**CITY OF CHARLOTTESVILLE
BOARD OF ARCHITECTURAL REVIEW
STAFF REPORT**

Certificate of Appropriateness Application

602-616 West Main (612 West Main), TMP 290003000

Project: New, mixed-use building

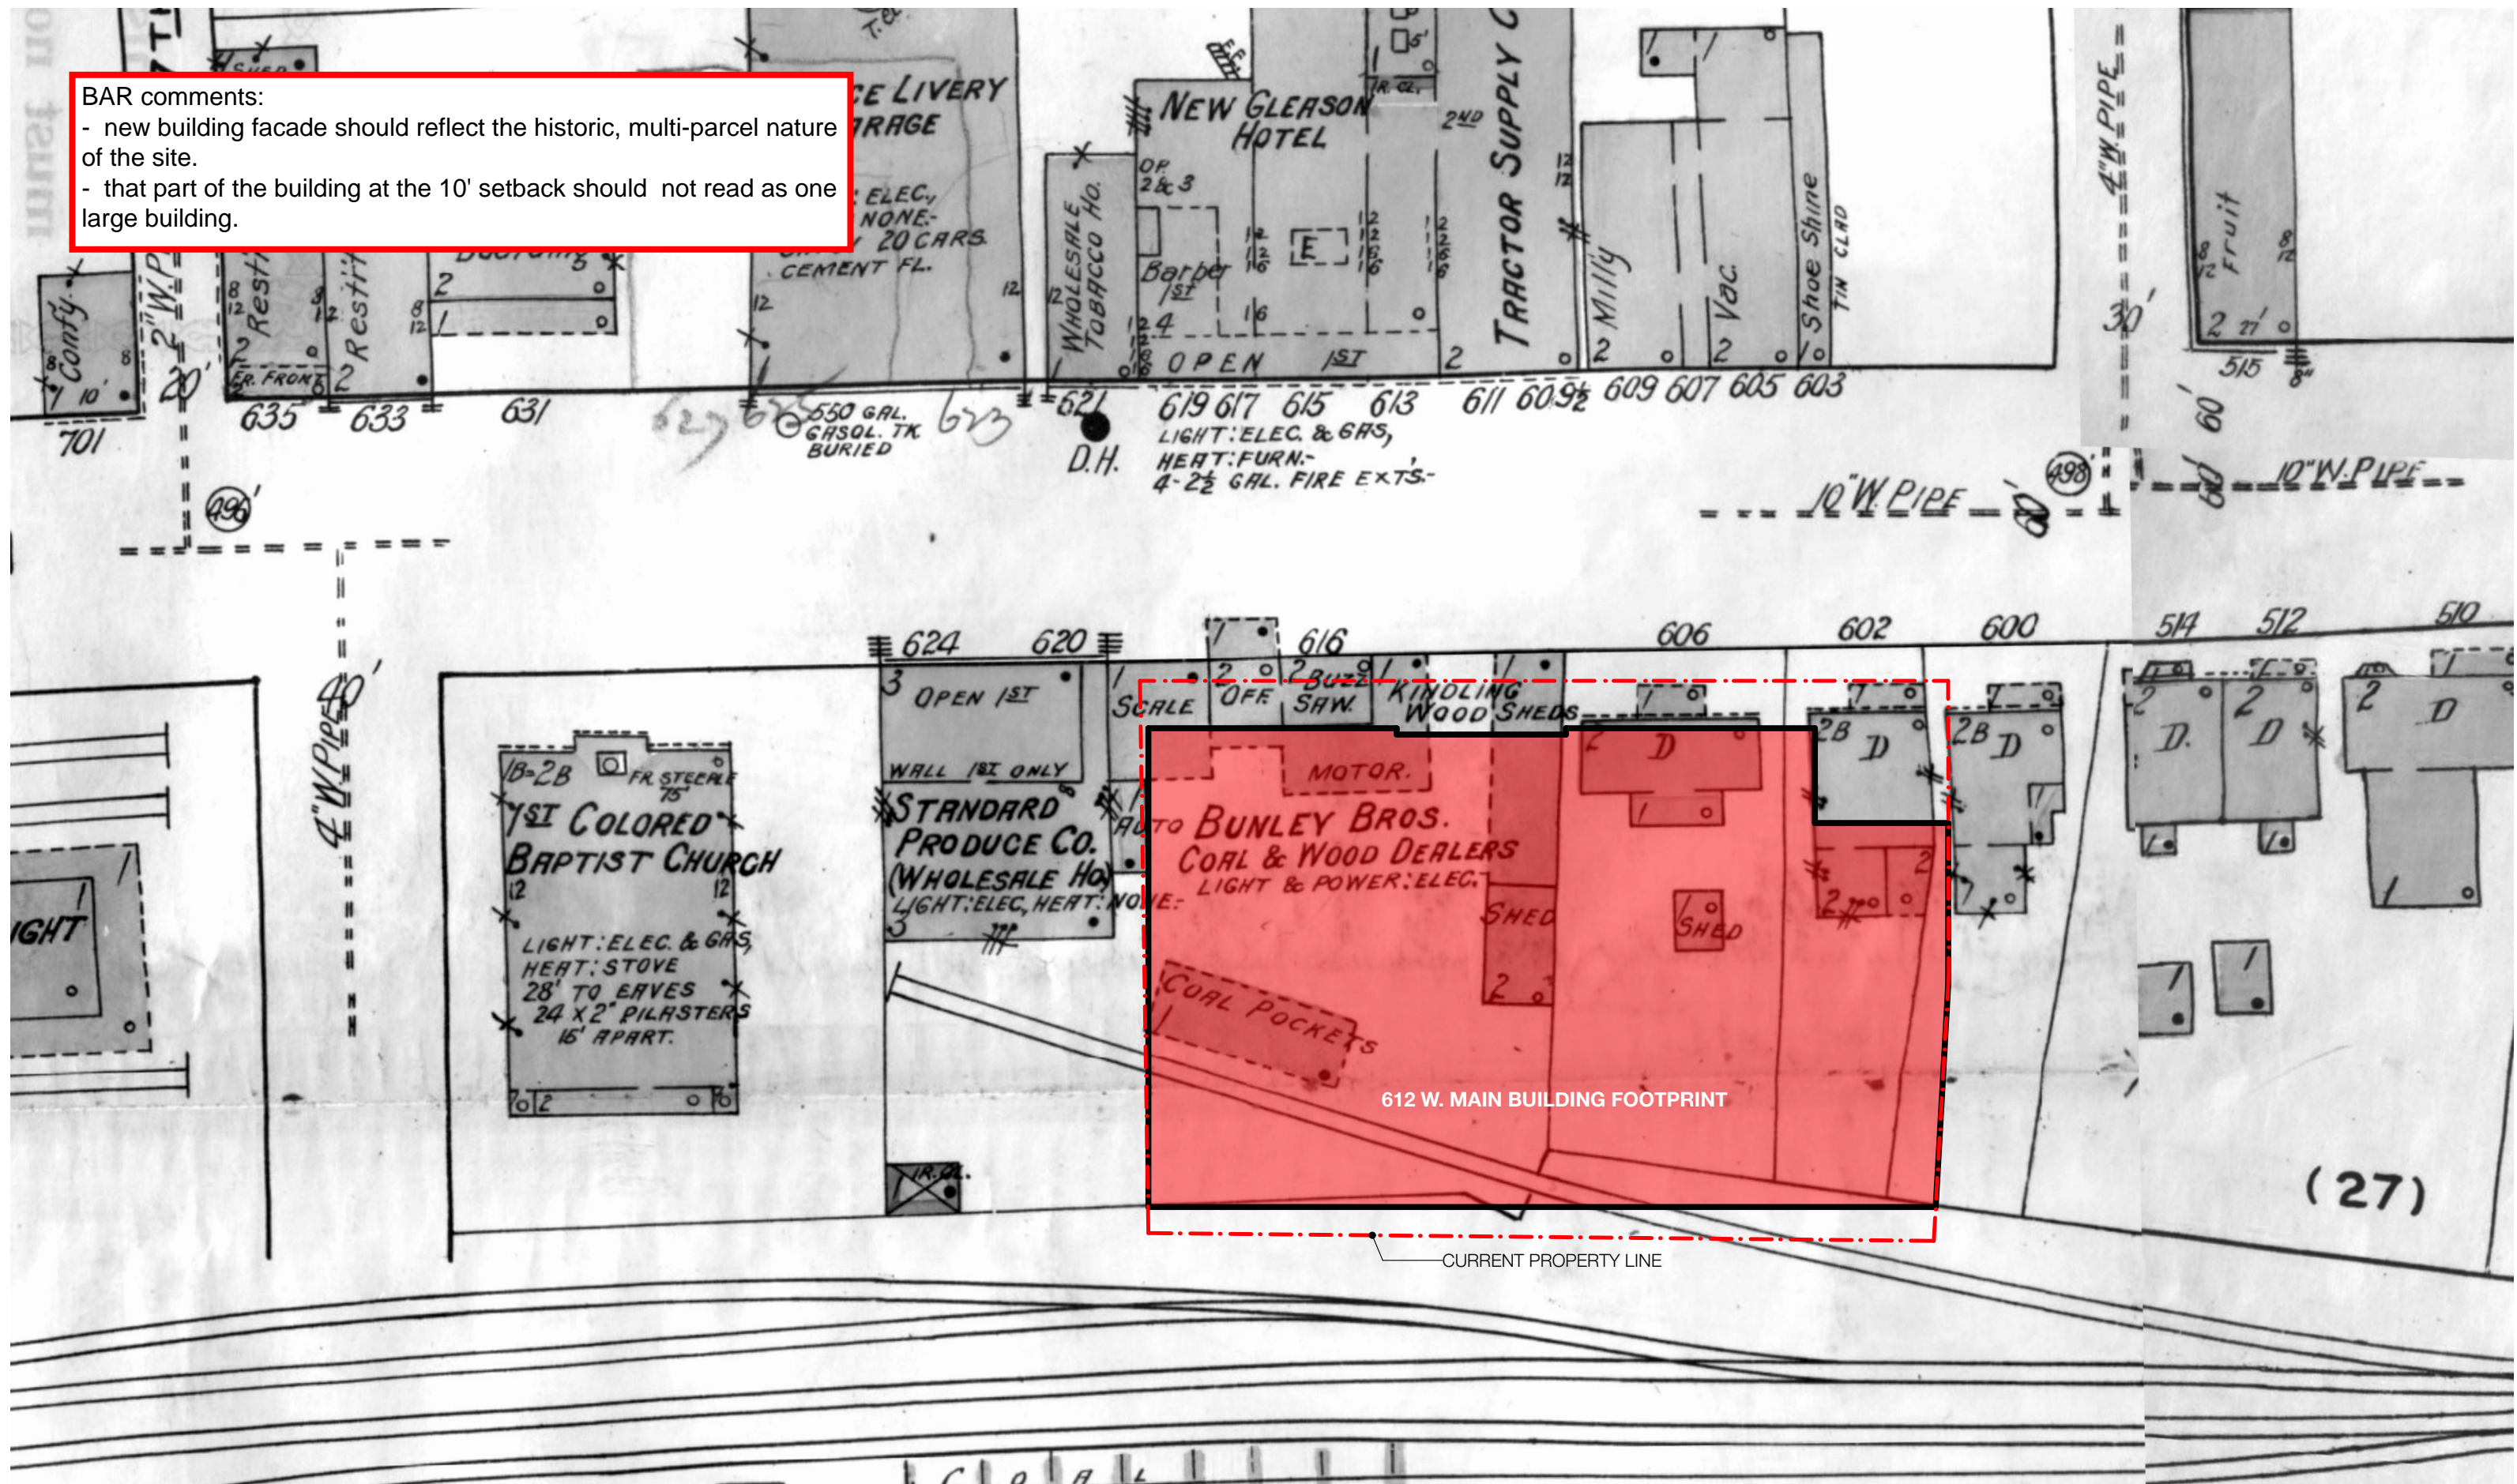
- new building facade should reflect the historic, multi-parcel nature of the site.
- that part of the building at the 10' setback should not read as one large building.

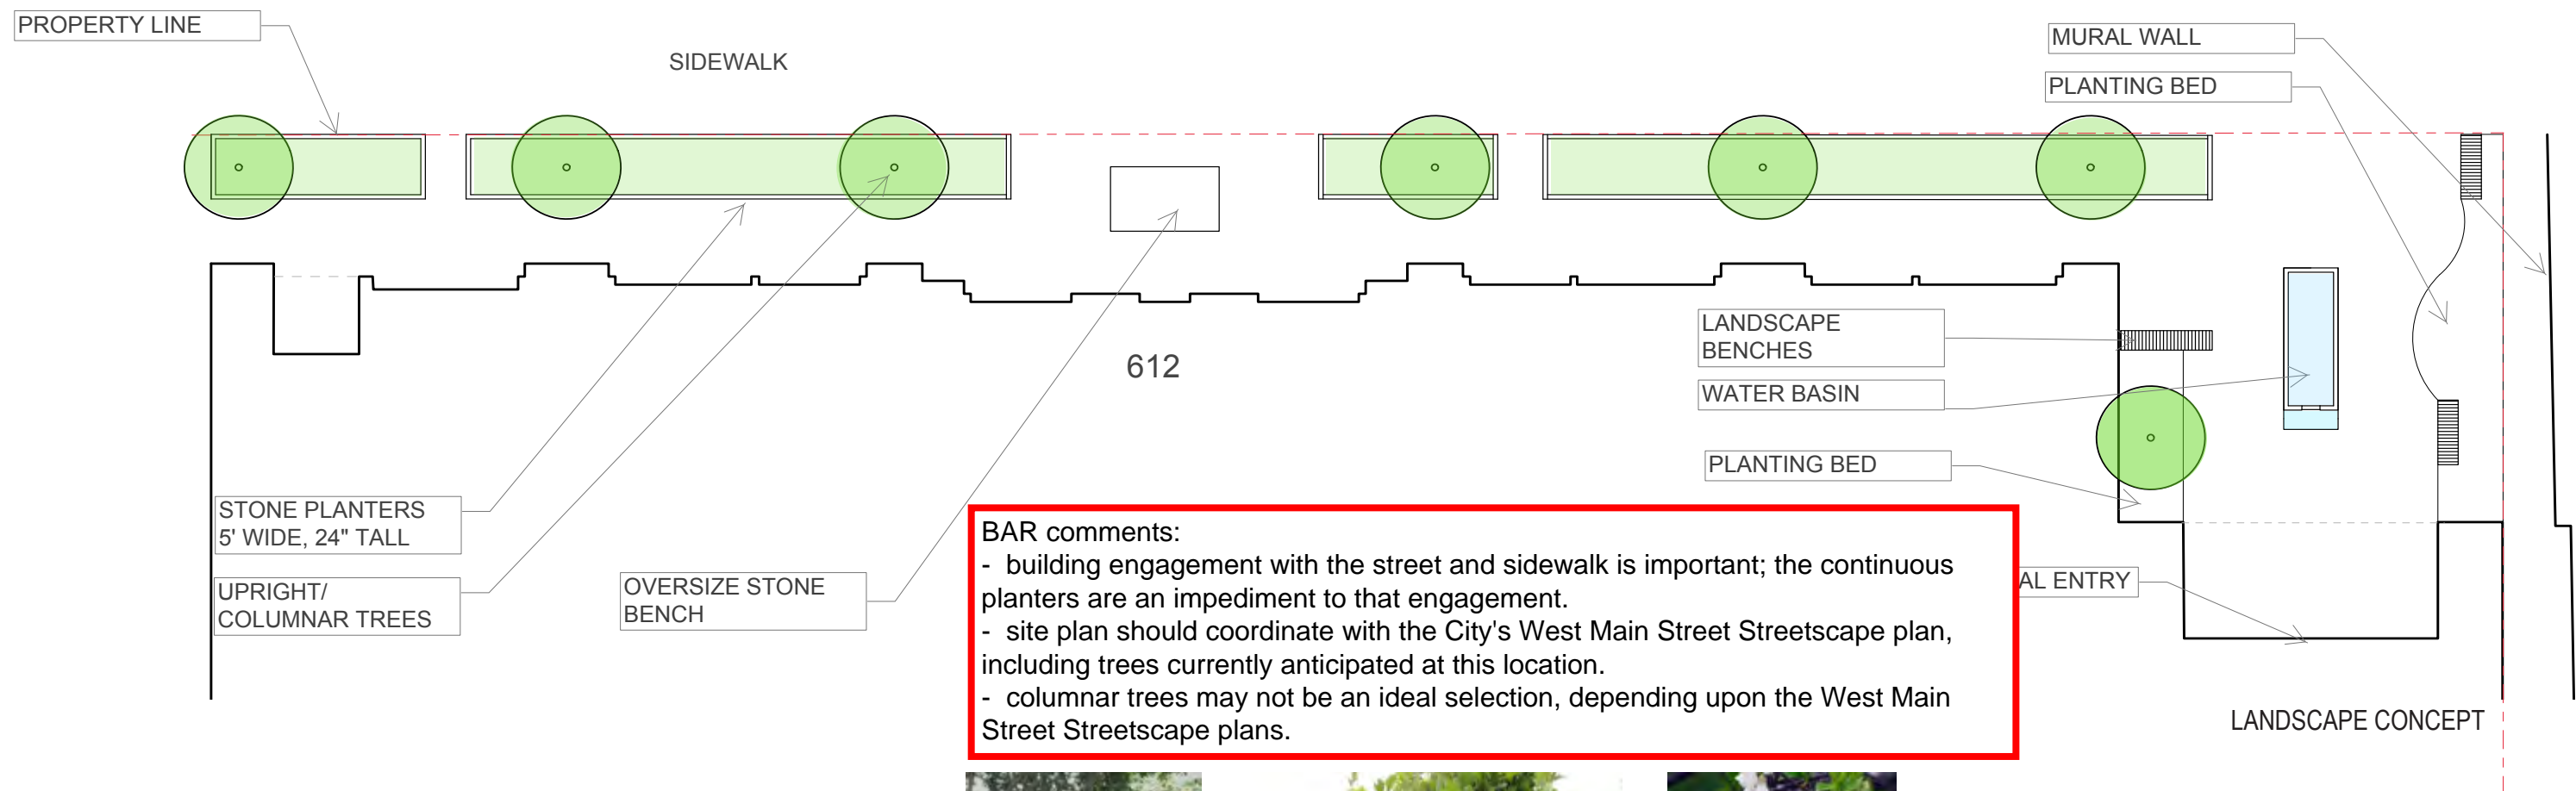
- building engagement with the street and sidewalk is important; the continuous planters are an impediment to that engagement.
- site plan should coordinate with the City's West Main Street Streetscape plan, including trees currently anticipated at this location.
- this site is an anomaly in this district - it's longer than most any other parcel. Horizontality vs. verticality is a critical issue to be resolved.

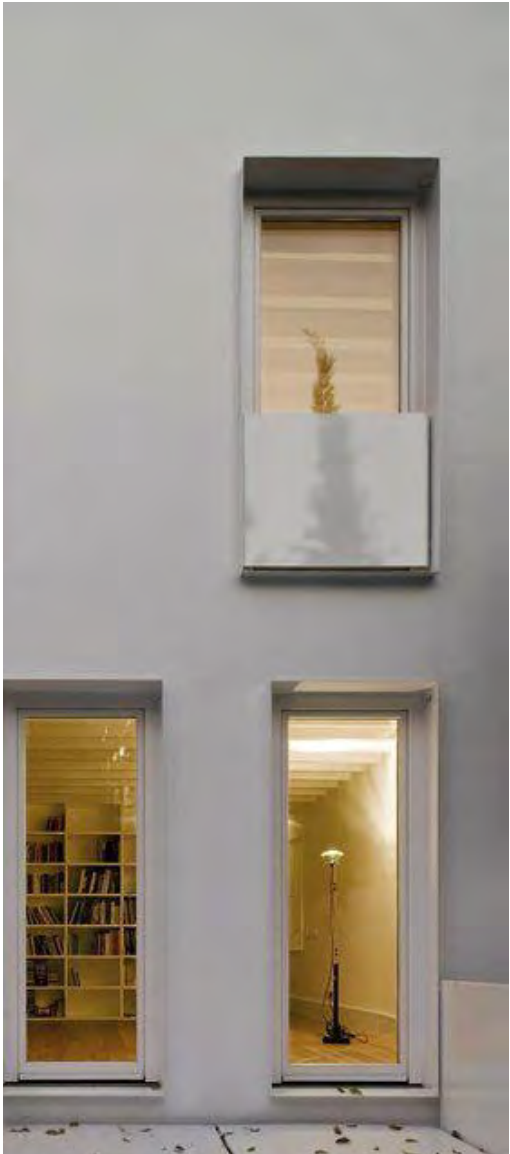
- brick and stucco are both appropriate materials for building in this ADC district.
- painted new brick is an acceptable material.
- thin brick is acceptable when detailed correctly, especially at corners.
- concern expressed about stucco that is susceptible to damage at ground level - a precast, brick or stone base of some sort could be appropriate as a more durable material at least to a height of 3' +/- above the sidewalk.

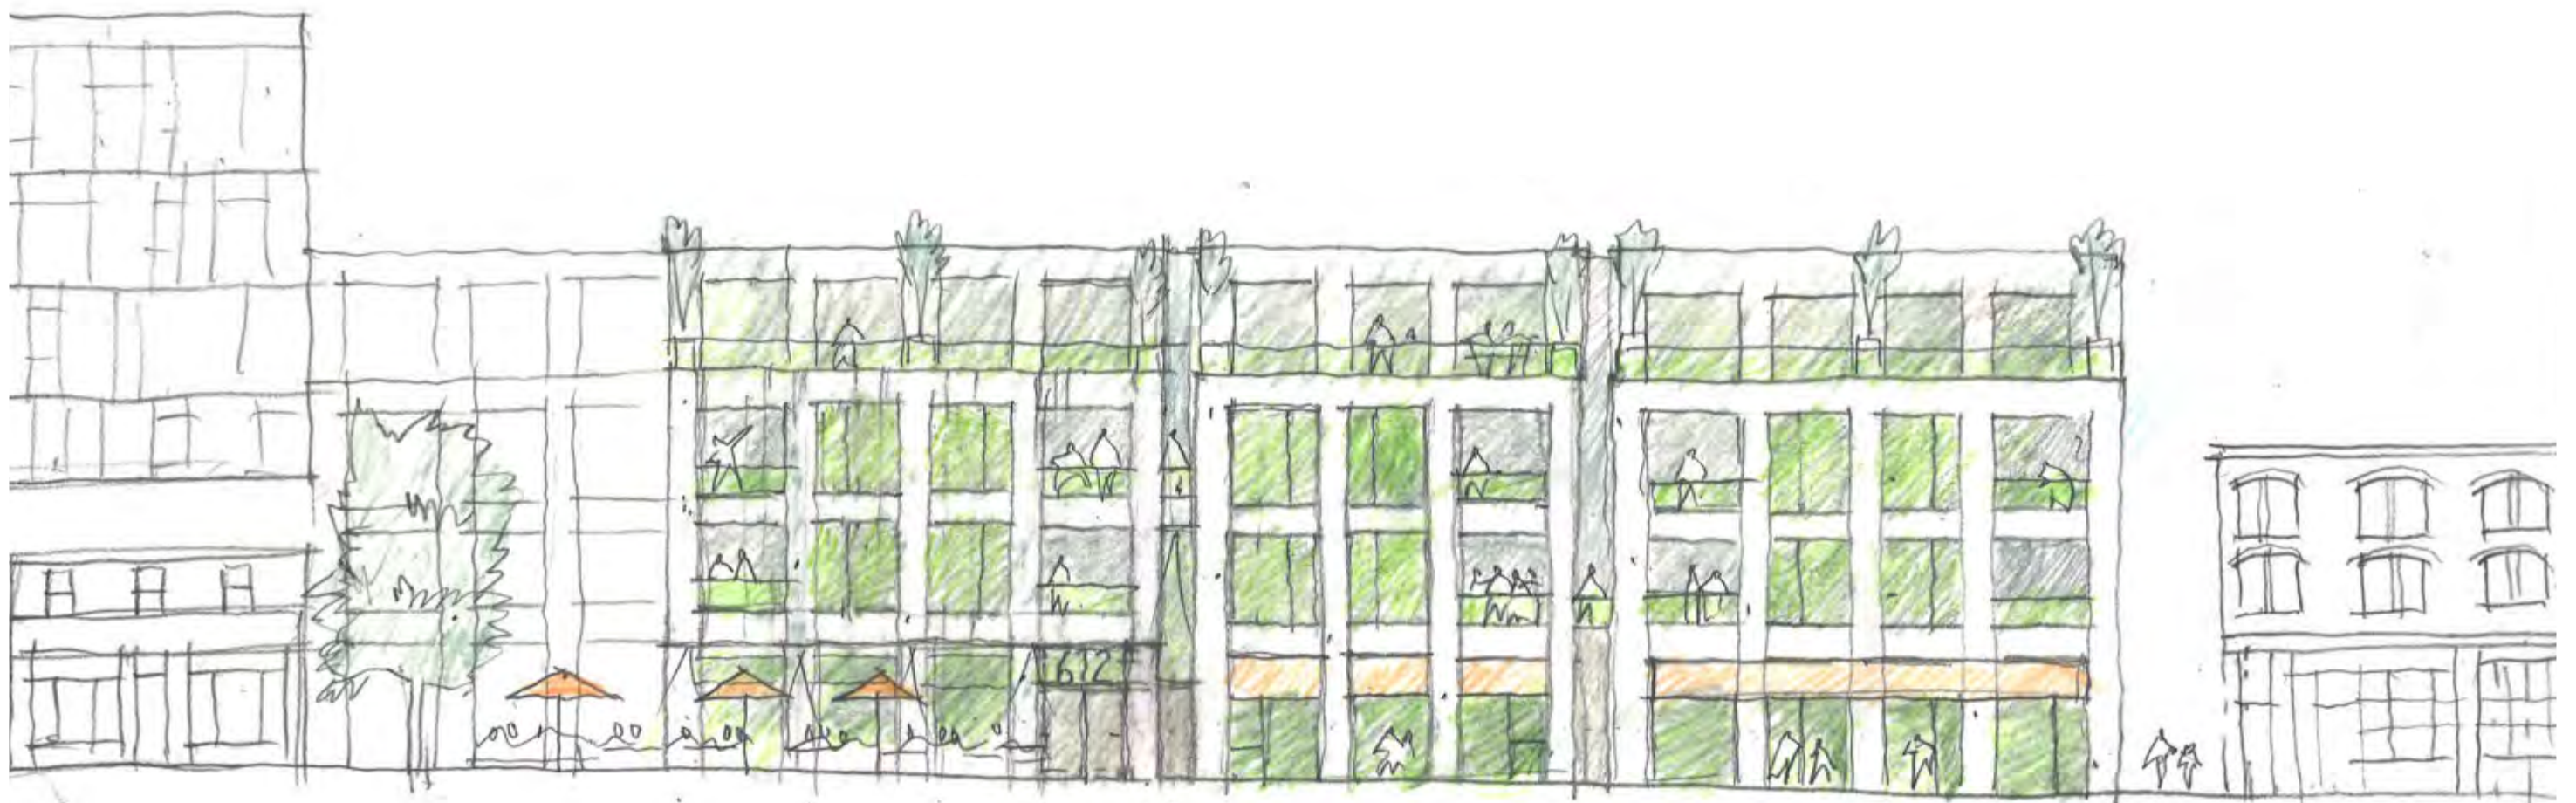
BAR comments:
 - acknowledgement that this is an unusual parcel on the West Main Street East district, as it is longer and has more street frontage than most parcels. No clear consensus that horizontal emphasis in the elevation is preferred over verticality.
